SUBJECT: Forwards revised mod proposal to reactor protection sys motor generator sets, incorporating two protective circuitry packages in series between each motor generator set & associated reactor protection sys bus. Diagram encl.

September 25, 1980  
LDR-80-263

Duane Arnold Energy Center

Proposed Modification to the RPS MG Sets

FIGURE 1 ELECTRICAL PROTECTION ASSEMBLY FOR RPS, BLOCK DIAGRAM

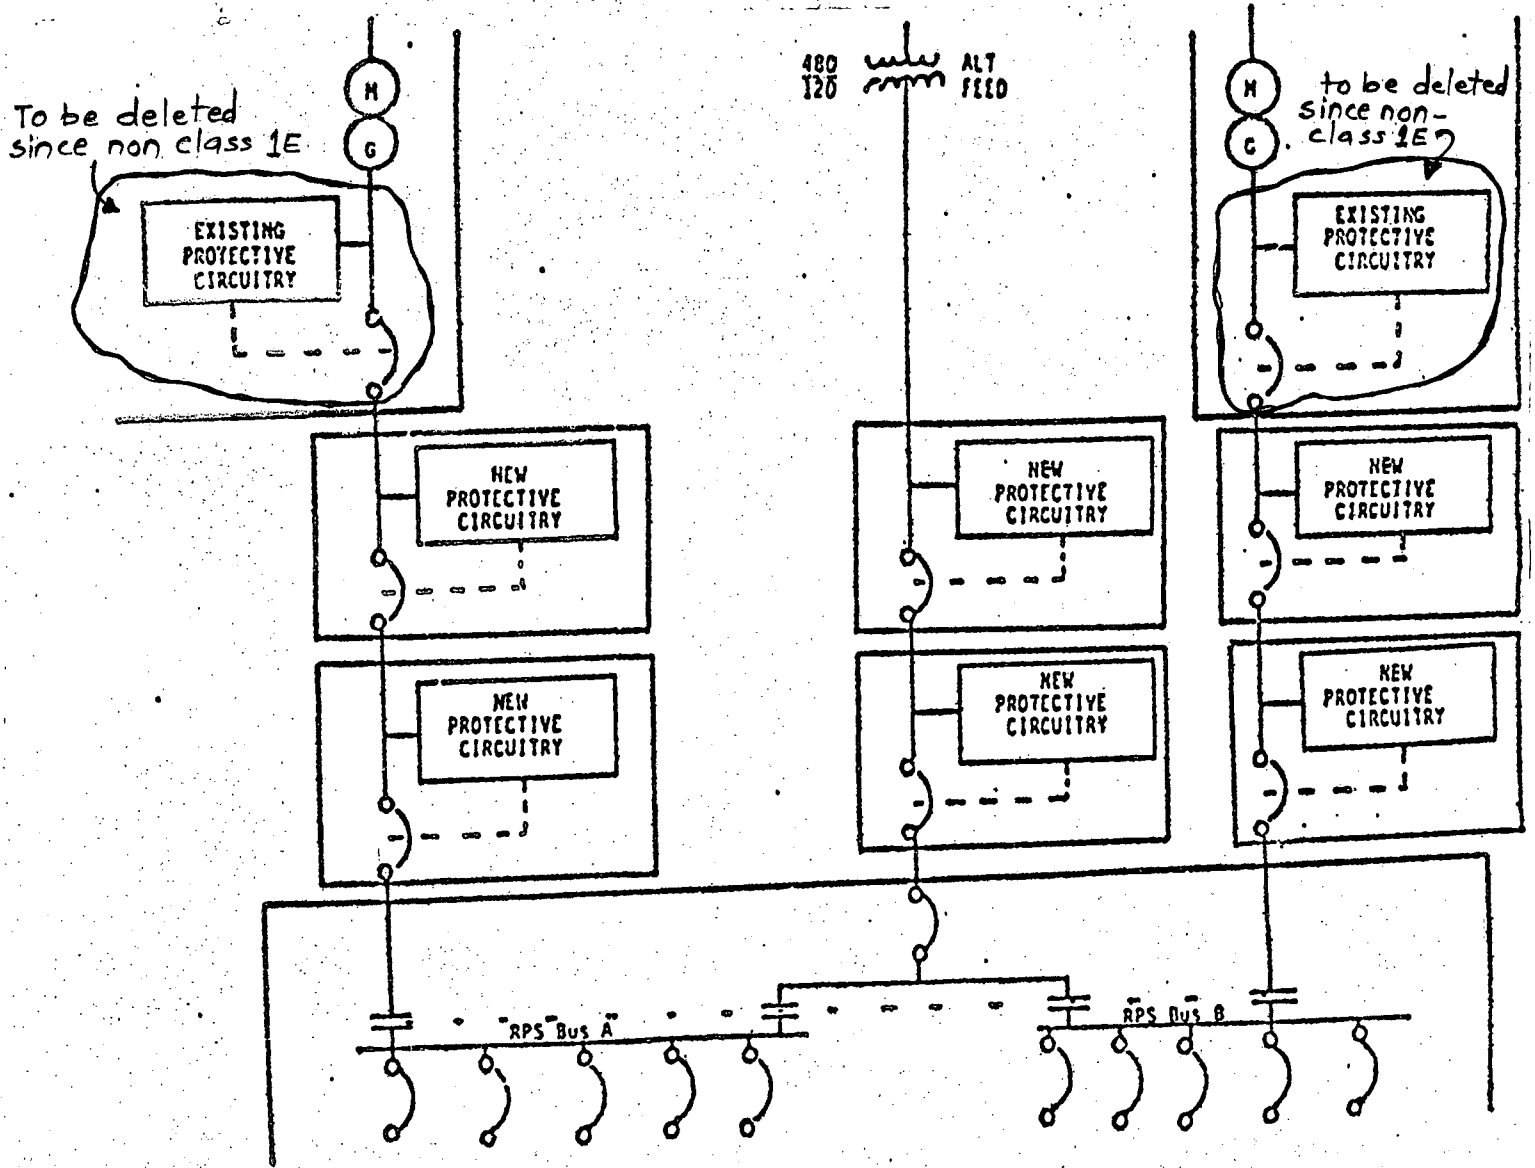
The modification described in Figure 1 is similar to the modification proposed by General Electric. It differs in that it deletes the existing protective circuitry which is non-class 1E. The modification incorporates two protective circuitry packages in series between each MG Set and associated RPS bus and between the alternate power source feeding the RPS panel. Each package will be environmentally and seismically qualified to meet the DAEC requirements. Each will consist of a circuit breaker, undervoltage, overvoltage, and underfrequency devices.

Note: The new protective circuitry consists of over voltage, under voltage and under frequency relays (all class 1E)
